## REFERRAL REPORT

TO: Vancouver City Council  
FROM: General Manager of Planning, Urban Design and Sustainability  
SUBJECT: CD-1 Text Amendment: 1980 Foley Street

**Figure 8: Response to constraints and six-storey expression on Great Northern Way**

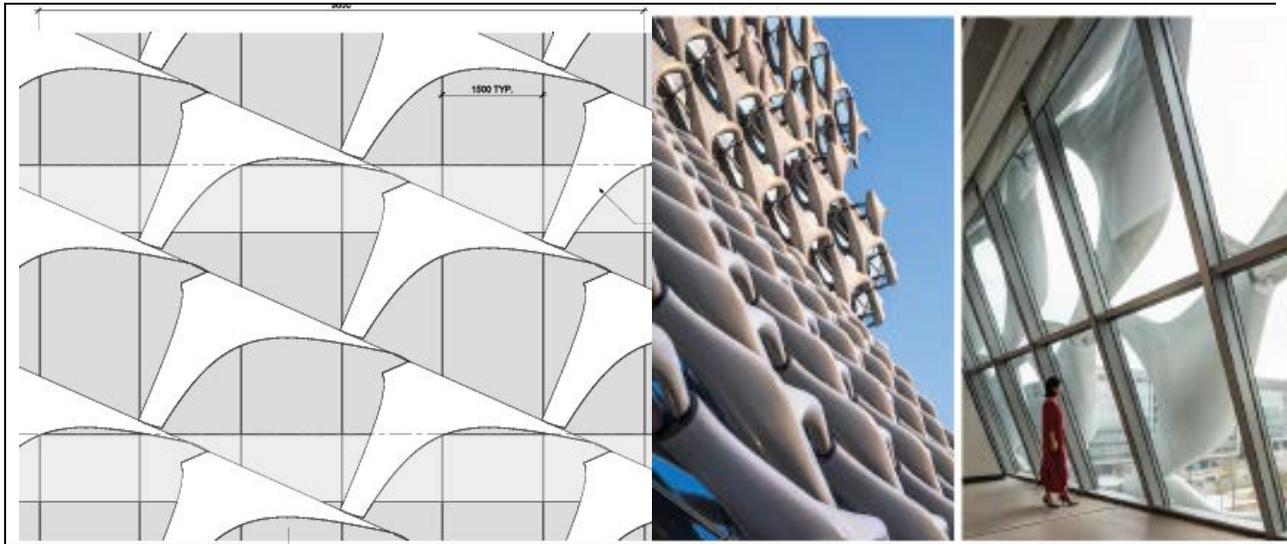
In responding to the *Great Northern Way CD-1 Guidelines* as well as early staff advice, the massing of the upper portion of the proposed building has been shifted northward away from Great Northern Way. This shift helps achieve four objectives:

- 1) It preserves some of the views of the North Shore Mountains and open skies, especially when standing at the top of the escarpment on 6th Avenue. In fact, this shift along with angling in the sides of the building can preserve more northward views than if the building was a broader form at 120 ft.
- 2) The six-storey elevation along Great Northern Way is aligned with the six-storey heights that exist to the east and are planned to the west of the site.
- 3) It pushes the bulk of the upper massing away from Great Northern Way helping to avoid a “canyon-effect” and to allow the public spaces along that street to be less dwarfed by tall wall-faces.
- 4) It allows for more sunlight hours on the China Creek right of way.
